SAFETY EVALUATION
FOR
VALIDATION OF BECHTEL COMPUTER CODE SASSI FOR APPLICATION TO
WATTS BAR NUCLEAR PLANT SOIL-STRUCTURE INTERACTION ANALYSIS
TENNESSEE VALLEY AUTHORITY (TVA)
WATTS BAR NUCLEAR PLANT (WBN) UNITS 1 AND 2
DOCKET NOS. 50-390 AND 50-391

2.0 PURPOSE AND SCOPE

Fig. 5 Comparison of SASSI Solutions for Surface and Embedded Foundation Conditions - Diesel Generator Building, EW Direction; 3% Damping ARS at Top of Building (Ref. 5)

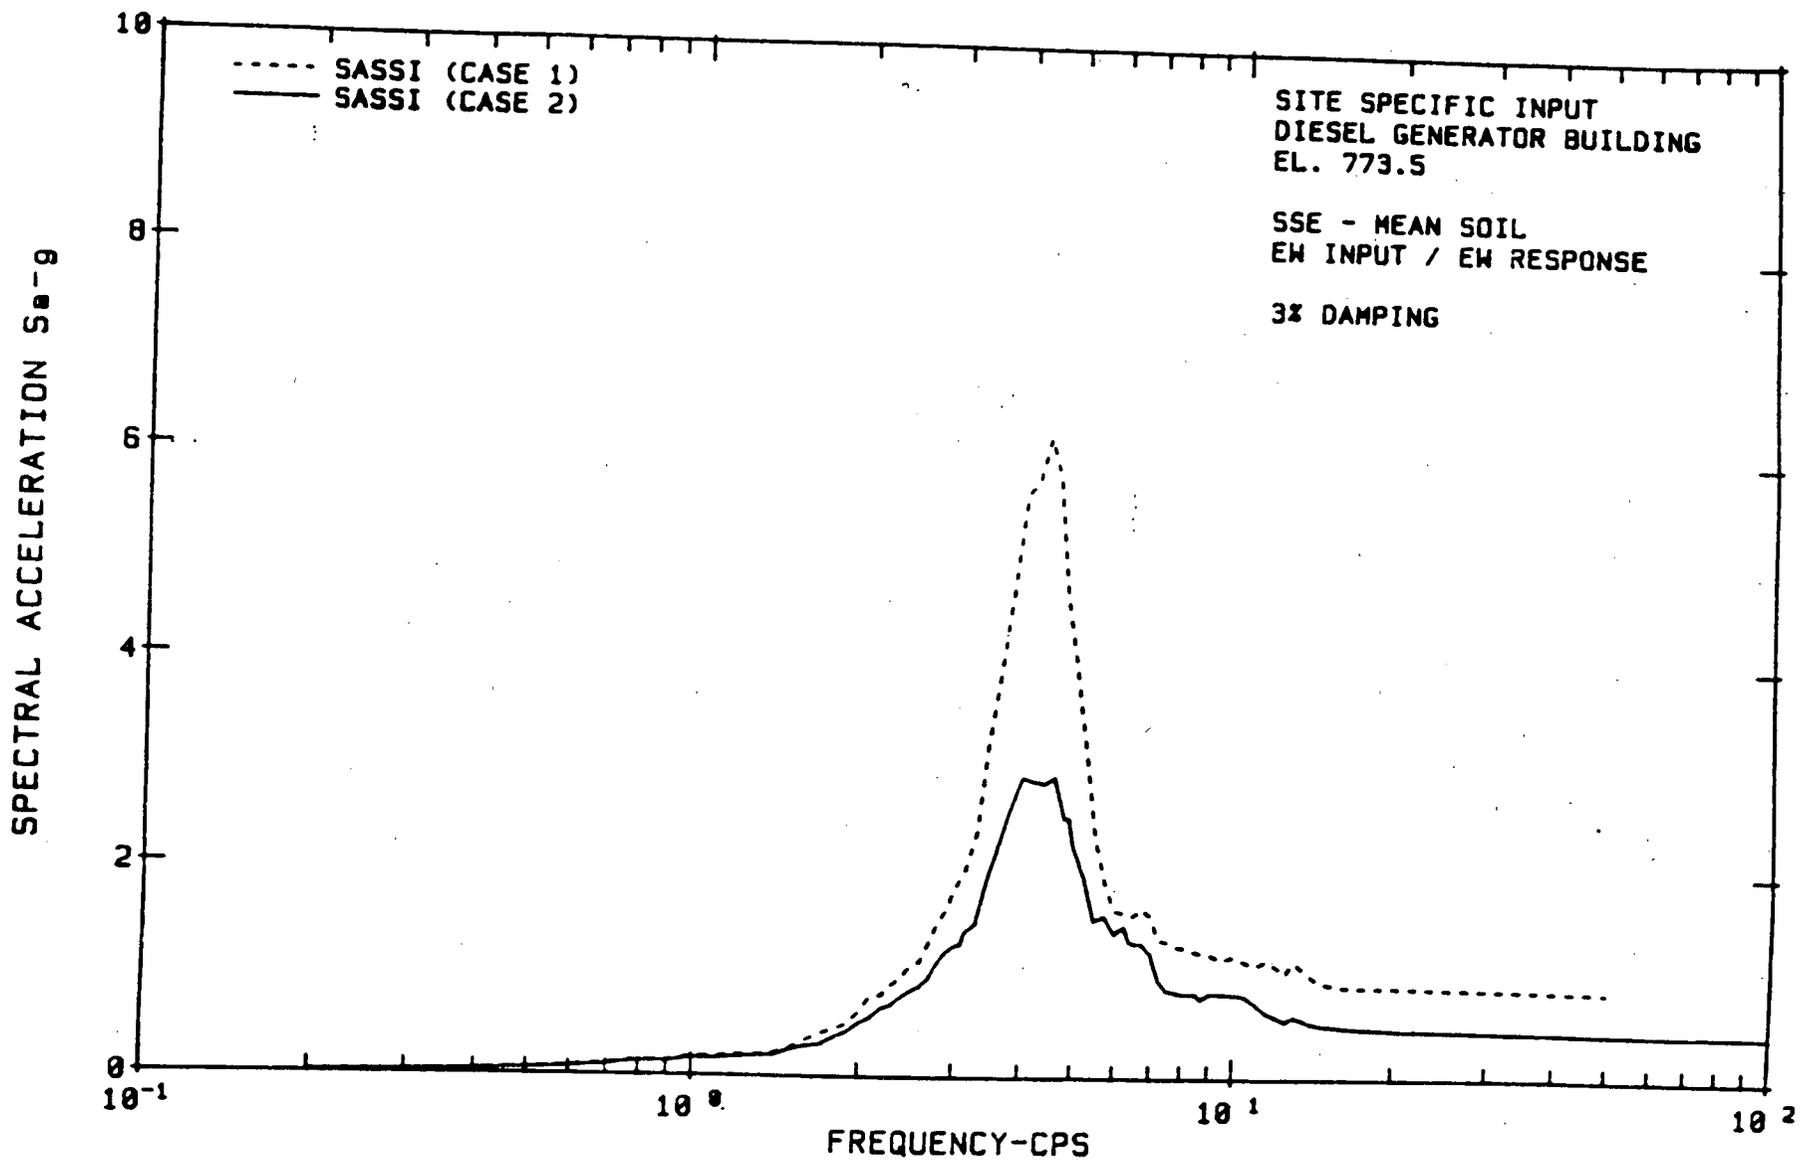
- (4) Comparing the solutions for SASSI Cases 1 and 2 or CLASSIF Cases 1 and 4 initially suggested that structural embedment has the effect of substantially reducing the structural response at WBN. This was especially the case with the DGB, as illustrated in Fig. 5. The staff and consultant, however, did not expect such a substantial reduction in view of the fact both structures are only shallowly embedded. Bechtel Validation Test Problem No. 9, which qualitatively benchmarks the SASSI solution for a shallowly embedded building against a CLASSIF solution for the same building founded on the ground surface, also indicates that the shallow embedment need not substantially reduce the structural response. In view of the incompatibility between the input motion and the hypothetical ground surface assumed in the Case 1 SSI model, as pointed out previously in finding (2), the staff envisioned that re-running the Case 1 analysis with the same SSI model and a compatible input motion will provide a better understanding of the significance of the structural embedment. The compatible input motion in this event would be the free-field motion computed at the hypothetical surface. In lieu of such reanalysis with either the SASSI or CLASSIF code, however, the staff believed the same purpose would be essentially fulfilled by simply comparing the free-field motions at Locations A, B, and C as shown in Fig. 4 in the case of the DGB, where the motion at Location C would be the compatible input motion mentioned previously. Bechtel therefore performed additional soil column analyses with the SHAKE code to compute the EW component of the motions at Locations B and C for the DGB. In addition, Bechtel extracted the EW translational component of the free-field scattered motion at the foundation, i.e., Location D as shown in Fig. 4, from the SASSI Case 2 analysis. Fig. 9 provides a spectrum comparison for the motions at the Locations A, B, C and D (Ref. 5, Appendix A). Around the system frequency of the SSI model for the DGB, which was estimated to be about 4.5 Hz, the spectrum acceleration of motion C is much lower than that of motion A. It suggests that should Case 1 be re-analyzed with motion C as the input the response of the DGB would not be as high as that with motion A as the input. That is, the reduction in structural response due to the shallow embedment of the basemat would indeed be less substantial than as initially suggested. The initial concern of the staff and consultant was therefore resolved.

Fig. 7 Comparison of SASSI and CLASSI Solutions for DGB ARS for the Hypothetic Surface-Founded Condition, EW-Direction at the Top of Building (Ref. 5)

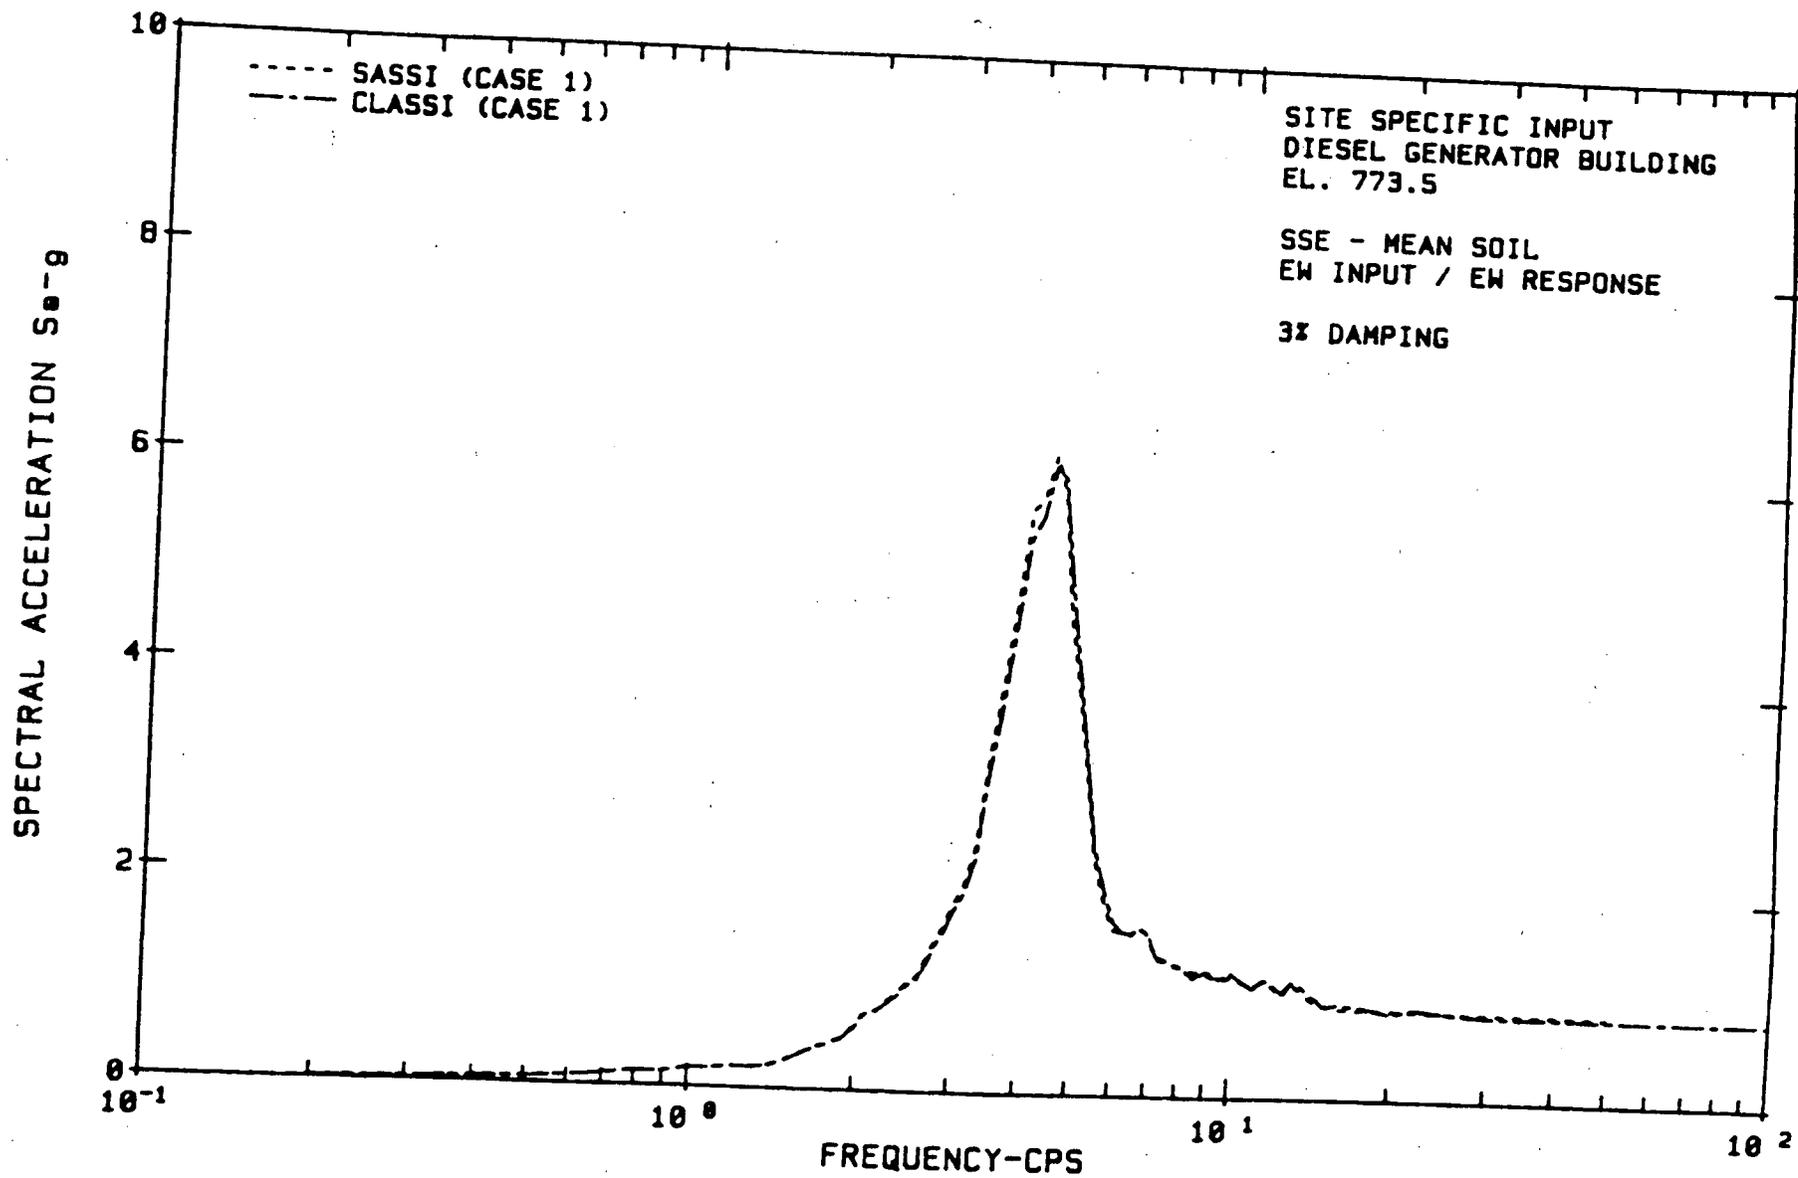
- (2) For the hypothetic surface-founded condition, the SASSI and CLASSIF solutions are comparable to each other. For example, Fig. 7 shows the ARS comparison at the center of the DGB roof. In the absence of structural embedment, such close comparison was anticipated according to the theories of the two codes. Thus the CLASSIF solution provided a plant-specific validation for the SASSI code in the case of surface-founded structures. The staff and consultant noted the incompatibility between the ground surface (e.g., Location A in Fig. 4), on which generation of the free-field input motion was based, and the hypothetic surface (e.g., Location C in Fig. 4) for the SSI model. However, because the incompatibility is common to both the SASSI and CLASSIF solutions the review finding regarding the SASSI code in the case of surface-founded structures remains valid.

Fig. 8 Comparison of SASSI and CLASSI Solutions for DGB ARS for the Embedded Condition, EW-Direction at the Top of Building (Ref. 5)

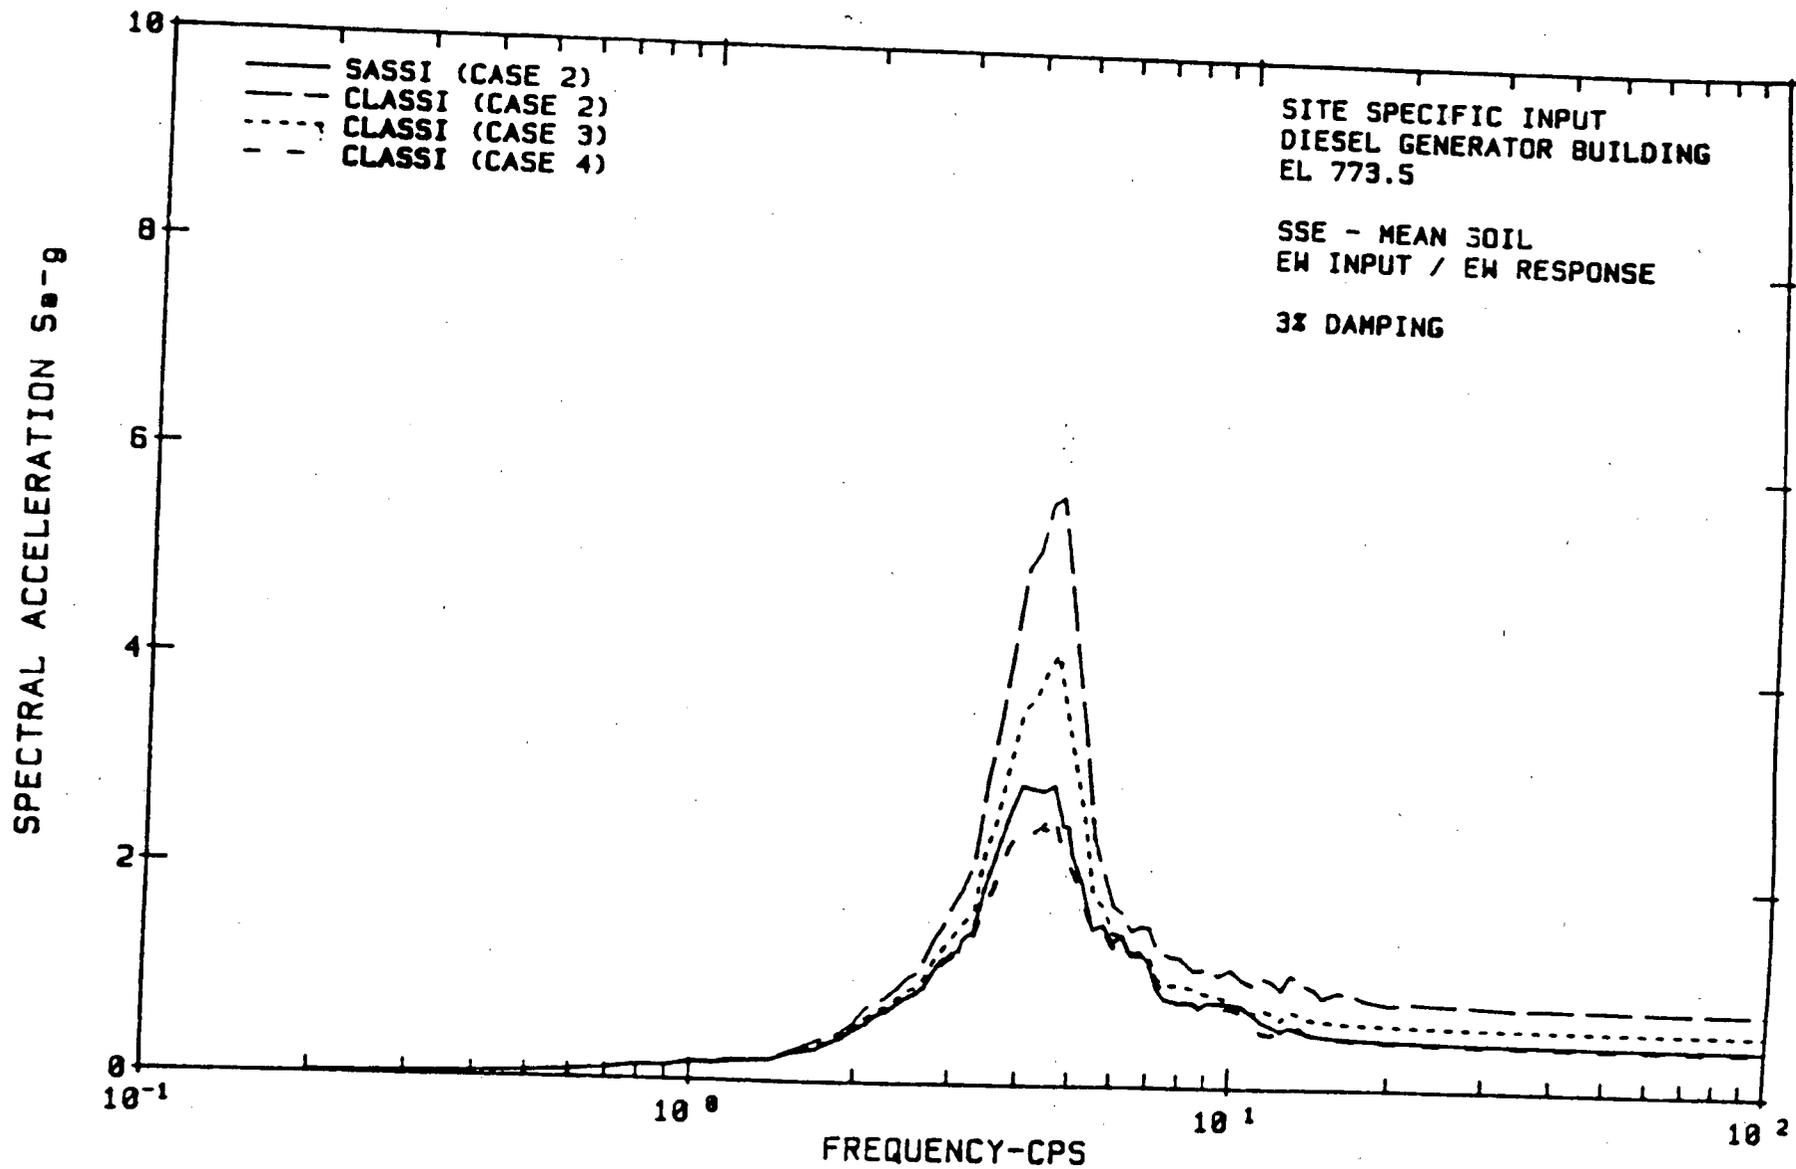
- (3) For the as-built embedded condition, the solution for SASSI analysis Case 2 compares well to that for CLASSIF analysis Case 4. This was anticipated because CLASSIF Case 4 was run using both the impedances and wave scattering functions that were generated from SASSI Case 2. For example, Fig. 8 shows the ARS comparison between the two solutions at the center of the DGB roof.

Thus the solution from CLASSIF Case 4 provided the SASSI code with a qualitative benchmarking in the case of embedded structures. In addition, the staff and consultant noted: (a) comparison between CLASSIF Cases 2 and 3 suggested that the empirically modified CLASSIF impedances are not a good approximation to the SASSI impedances at WBN, and (b) comparison between CLASSIF Cases 3 and 4 suggested the wave scattering due to structural embedment is important at WBN.

Fig. 9 Comparison of 5% Damping Spectra in EW Direction for Free-Field Motion at Locations A, B, C and D Shown in Fig. 4 for DGB (Ref. 5)

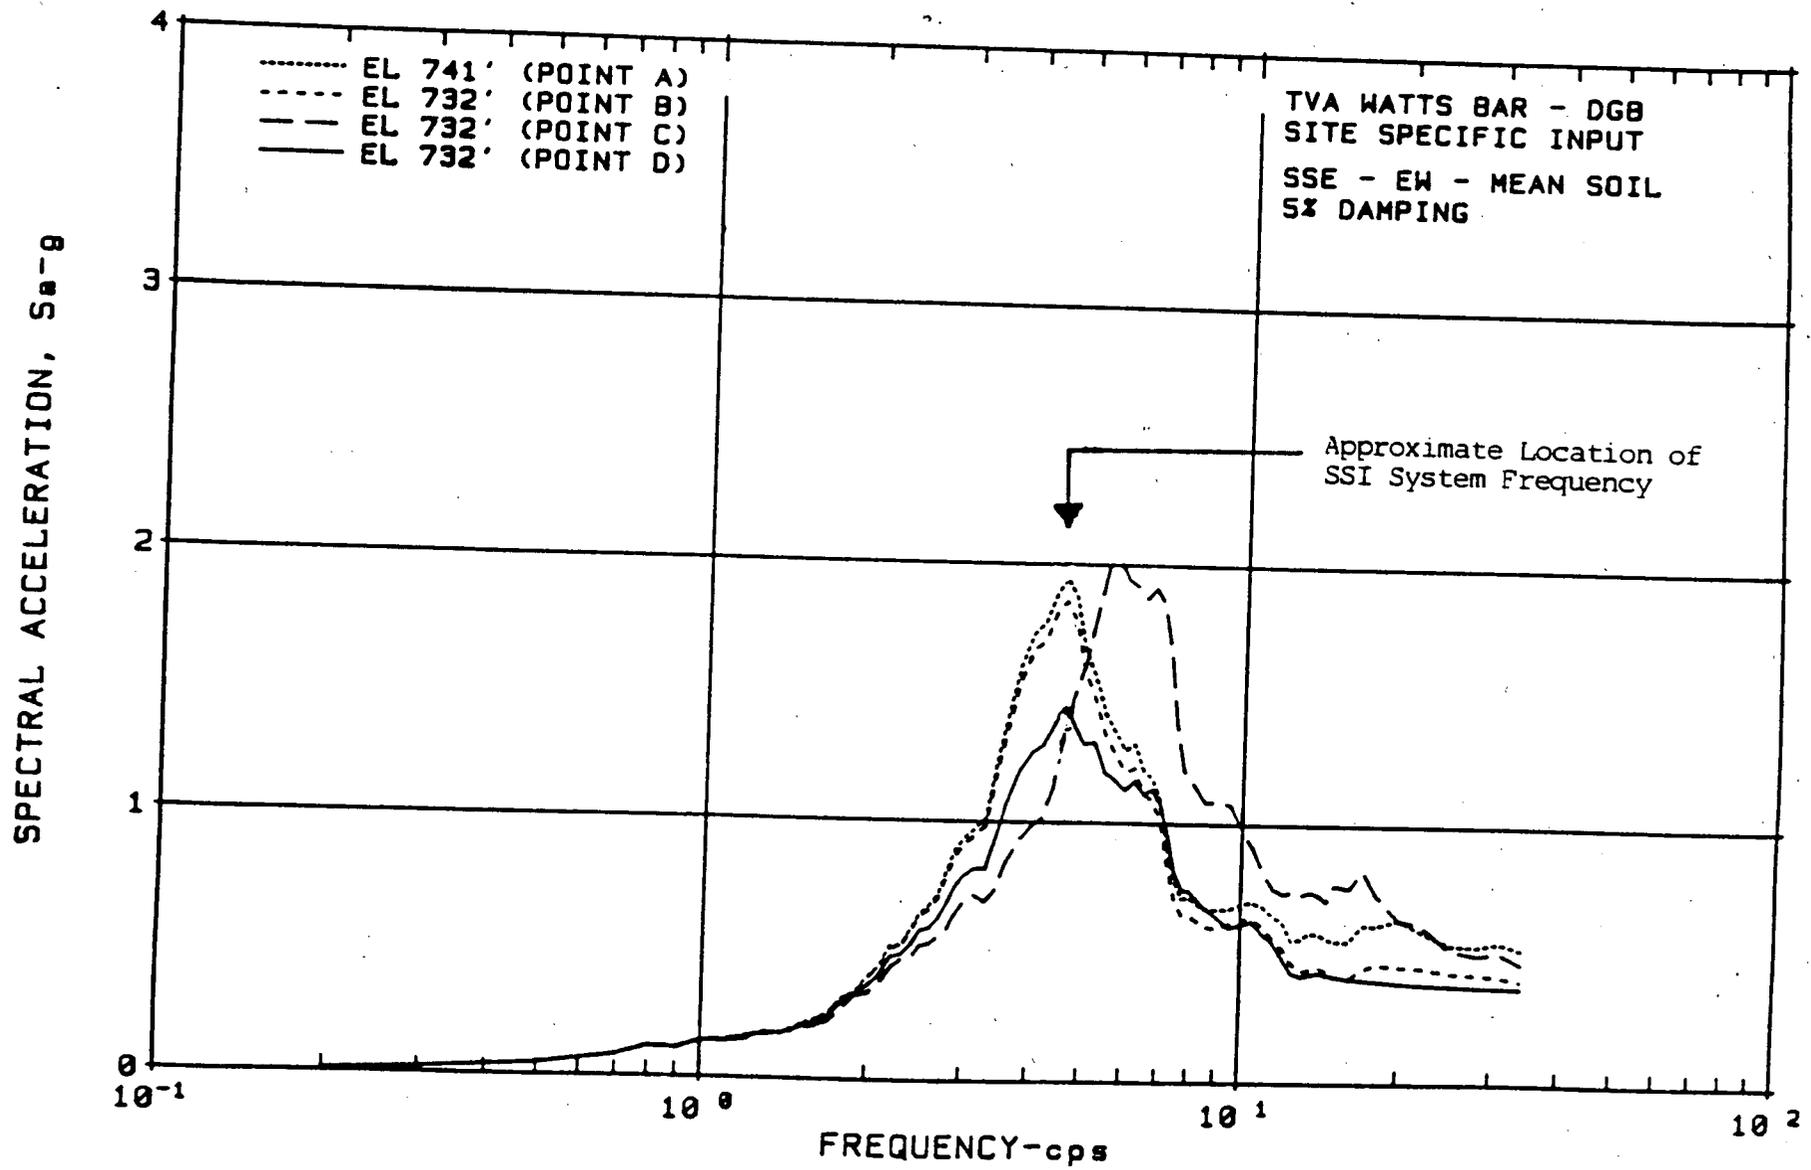
- (5) As discussed previously in finding (3), the staff and consultant noted the significance of wave scattering on the response of the DGB and RWST due to the structural embedment. The spectrum comparison for motions A, B and D as shown in Fig. 9 led to the same observation. As an additional evidence, Bechtel provided a summary of the results from some published studies on the responses recorded in and around a 1/4-scale containment model during several strong-motion earthquakes (Ref. 7). The scaled model is located in Lotung, Taiwan, and is moderately embedded in a soft soil foundation. Fig. 10 illustrates the vertical cross section of the scaled containment model. Fig. 11 shows the variation of the recorded free-field motions from the surface to -47m in the ground during one of the earthquakes. The earthquake,
